Office Action Summary

09/868,938

NISHIO ET AL.

DETAILED ACTION

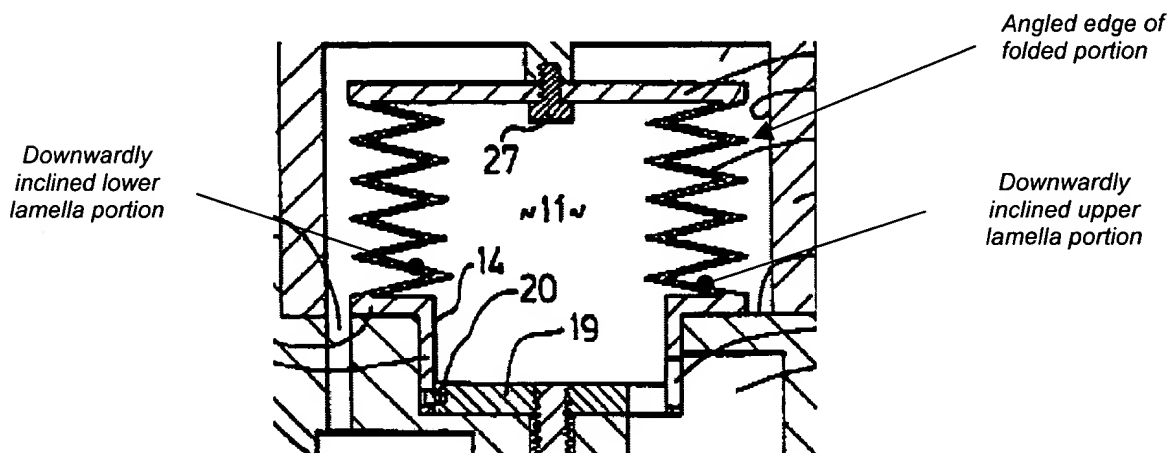
2. Claims 7 and 10 are rejected under 35 U.S.C. 103(a) as being unpatentable over Thomin et al. (WO 99/31388) in view of Boedecker et al. (4,655,690). Thomin et al. teach a fluid apparatus having a bellows 12 with extending and contracting portions configured by forming ridge-like folds and valley-like folds 18 in a vertically alternate and continuous manner, that are extendingly and contractingly deformable in an axial direction. The bellows are placed in a pump body 1 such that the axial direction defines a vertical axis. Figure 2 illustrates an inner pumping chamber 11 (corresponding to the claimed liquid chamber) formed inside of bellows 12; an outer pumping chamber 10 (corresponding to the claimed air chamber) formed outside of the bellows 12; and a suction (or inflow, as in claim 4) port 43 and a discharge (or outflow, as in claim 4) port 45 formed in an inner bottom face of the pump body facing the inner pumping chamber. Figure 2 further illustrates that the bellows are formed into a shape in which a lower one

of upper and lower lamella portions of each of the ridge-like folds is downwardly inclined toward the vertical axis, in both the extending and contracting state (see the accompanying figure), and in the contracting state, the upper and lower lamella portion of each ridge-like fold is formed to be downwardly inclined.

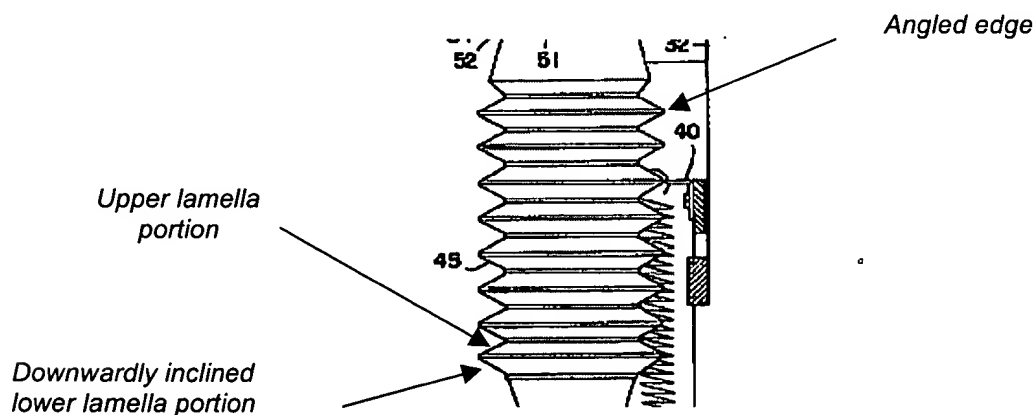
3. Claims 7 and 10 are rejected under 35 U.S.C. 103(a) as being unpatentable over Hope et al. (4,231,724) in view of Boedecker et al. Hope et al. teach a fluid apparatus having a bellows 45 configured by a pump in which a bellows that has an extending and contracting portion configured by forming ridge-like folds and valley-like folds in a vertically alternate and continuous manner (see column 5, lines 7-13), and that is extendingly and contractingly deformable in an axial direction. The bellows 45 are placed in a main frame 12 (corresponding to the claimed pump body) such that the axial direction extends along a vertical axis, and include a chamber inside of the bellows. Hope et al. further teach a suction port 83 and a discharge port 63 and that the extending and contracting portion of the bellows is formed into a shape in which a lower one of upper and lower lamella portions of each of the ridge-like folds is downward inclined toward the vertical axis, in both the extending and contracting state (see the accompanying figure), and in the contracting state, the upper and lower lamella portion

of each ridge-like fold is formed to be downwardly inclined. With regards to claim 10, since the bellows are exposed to air, it stands to reason that there is an air chamber outside of the bellows. That is, outside of the bellows 4 and within main frame 12, constitutes the claimed air chamber.
